DEPARTMENT REPORT

SUBJECT: [H-2024-0037](#)
Pollard North – MDA, PP, RZ

LOCATION: Generally located approximately 1/4 mile north of W. Chinden Blvd. at the north end of N. Levi Ave. on the north side of W. Waverton Dr., in the south 1/2 of Section 21, T.4N., R.1W. (Parcel #S0421438475).

F. Common Driveway Exhibit

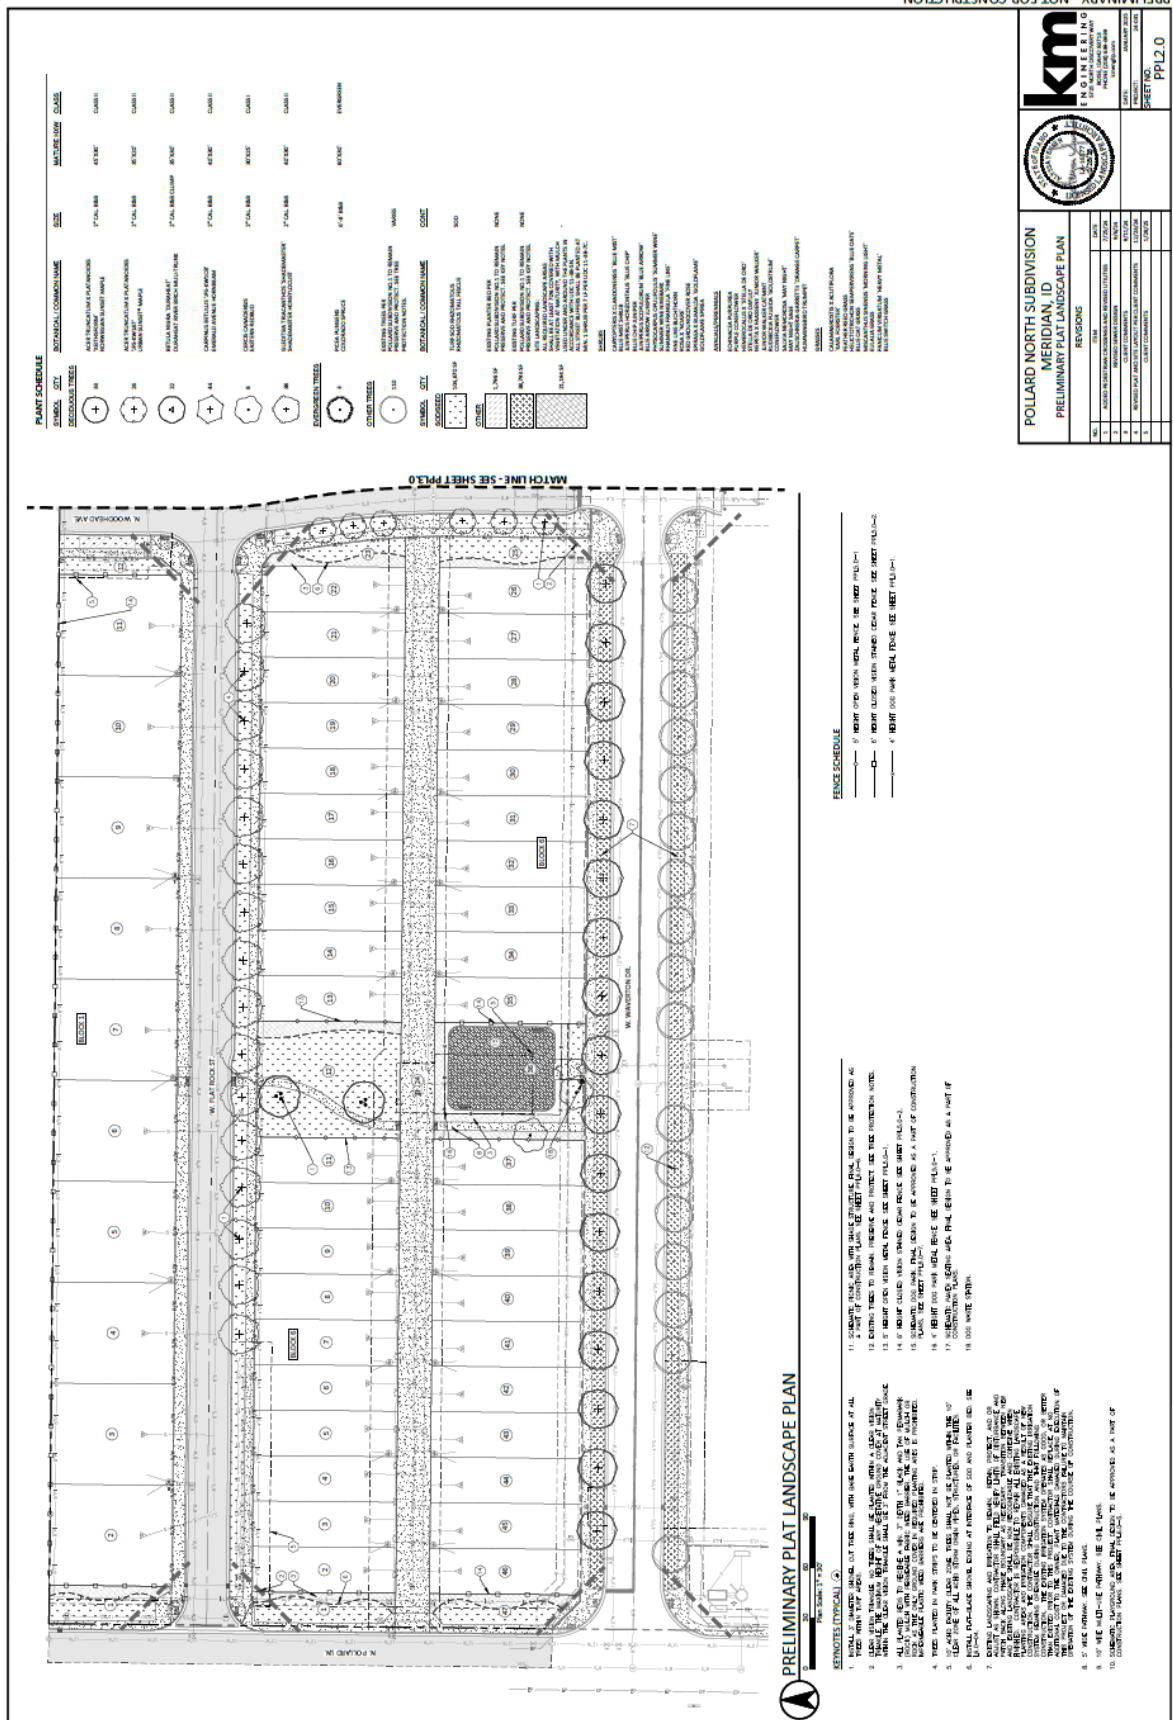
Common driveways: Common driveways are required to comply with the standards listed in UDC 11-6C-3D. One (1) common driveway is proposed on Lot ~~15~~ 16, Block 3 for access to Lots ~~13~~ 14 and ~~14~~ 15. A common driveway exhibit is included in Section VII.F that demonstrates compliance with the standards listed in UDC 11-6C-3D. **Perpetual ingress/egress shall be required either by a recorded easement or as a note on a recorded final plat. The easement or plat note shall include a requirement for maintenance of a paved surface capable of supporting fire vehicles and equipment. Solid fencing adjacent to common driveways is prohibited, unless separated by a minimum five-foot wide landscaped buffer planted with shrubs, lawn or other vegetative groundcover – if fencing is proposed along the south side of Lot ~~15~~ 16, Block 3, a 5-foot wide buffer should be provided.**

4. The common driveway shall be constructed in accord with the standards listed in UDC 11-6C-3D and per the common driveway exhibit in Section VII.F.
5. Perpetual ingress/egress shall be required for the common driveway either by a recorded easement or as a note on a recorded final plat as set forth in UDC 11-6C-3D. The easement or plat note shall include a requirement for maintenance of a paved surface capable of supporting fire vehicles and equipment.

G. Landscape Plan (dated: 7/25/24 12/23/2024 1/28/2025) - REVISED

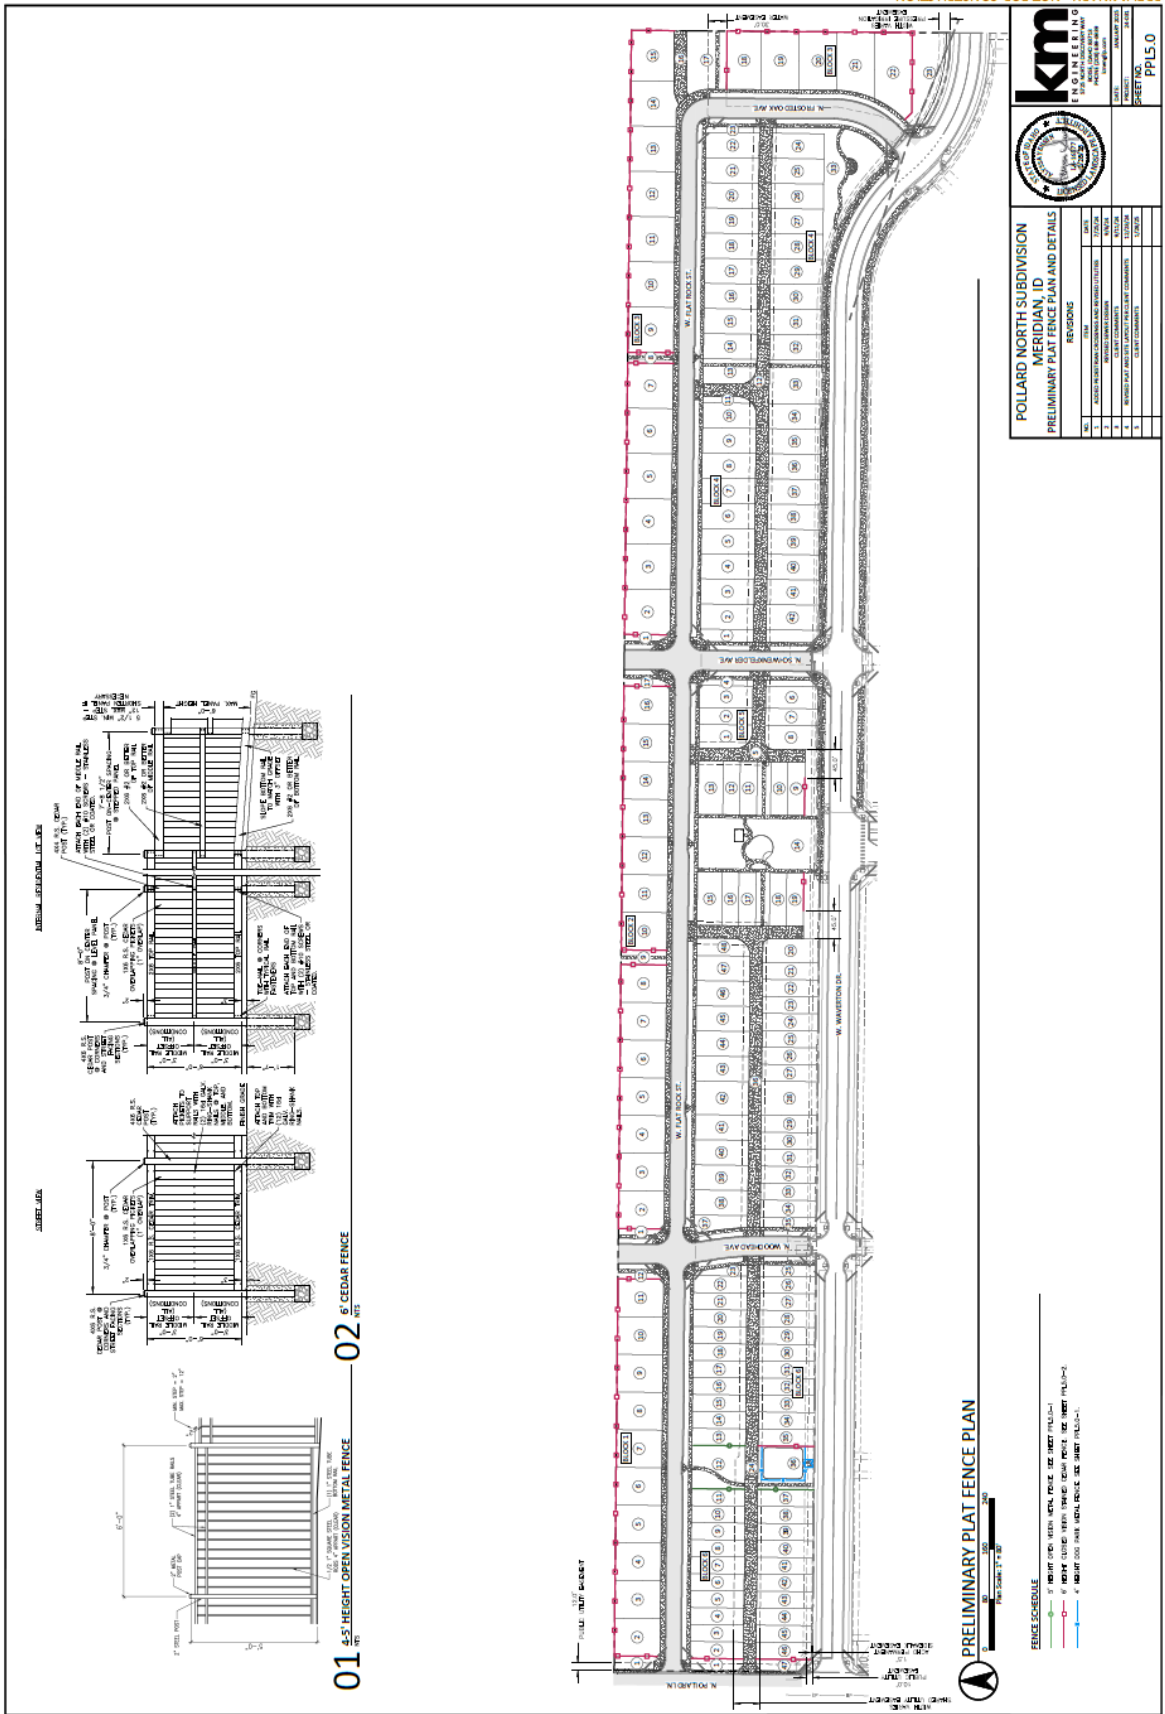
The landscape plan depicts 5-foot tall open vision metal fencing and 6-foot tall closed vision stained cedar fencing on the shared property line of some building and common lots. **The developer is responsible for constructing fences abutting all pathways and common open space lots to distinguish common from private areas. Fencing should be depicted on a revised**

The pathways along the east and west sides of Lot 14, Block 5 abut the residential property lines and don't have the required 5-feet of landscaping on both sides of the pathway as set forth in UDC 11-3B-12C. The landscape plan should be revised to comply with these standards; or, a request for alternative compliance may be submitted to this standard as set forth in UDC 11-5B-5.

- ii. Depict fencing abutting pathways and common open space lots to distinguish common from private areas as set forth in UDC 11-3A-7A.7; or, submit a request for alternative compliance to this standard.

- iii. Depict a minimum 5-foot wide landscape strip along both sides of the pathways located along the east and west sides of Lot ~~45~~ 14, Block 5 with landscaping in accord with the standards listed in UDC 11-3B-12C; or, submit a request for alternative compliance to this standard as set forth in UDC 11-5B-5.

- iv. If solid fencing is proposed along the south side of Lot ~~45~~ 16, Block 3, a 5-foot wide buffer should be provided planted with shrubs, lawn or other vegetative groundcover as set forth in UDC 11-6C-3D.5. The plat should be adjusted accordingly.
